## MU9C8338/8358L Ethernet Filter Interface Errata Sheet

MU9C8338 Revision C and MU9C8358L Revision A Ethernet Filter Interfaces.

Figure 1: LANCAM /FF Signal Inverter Workaround

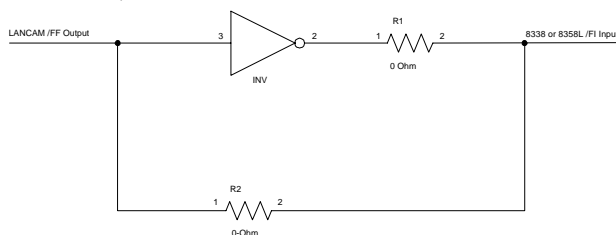
/FI input expects a 0 to 1 transition in order to cause the Full Flag interrupt, while the LANCAM /FF output goes from 1 to 0 when a CAM Full condition occurs.

This problem affects applications where the Full Flag Interrupt is enabled in the System Target register (STARG) with bits [1:0] = 10.

MUSIC recommends that all designs requiring the Full Flag interrupt have an inverter placed between the /FF output and /FI input. If the inverter is obtained from logic other than a programmable logic device, a 0-Ohm bypass resistor is recommended so the PCB will be compatible with any later revisions. In the example shown in Figure 1, R1 is installed and R2 is omitted. If the inverter is not required and can not be removed from the PCB, resistor R1 can be omitted and R2 installed.
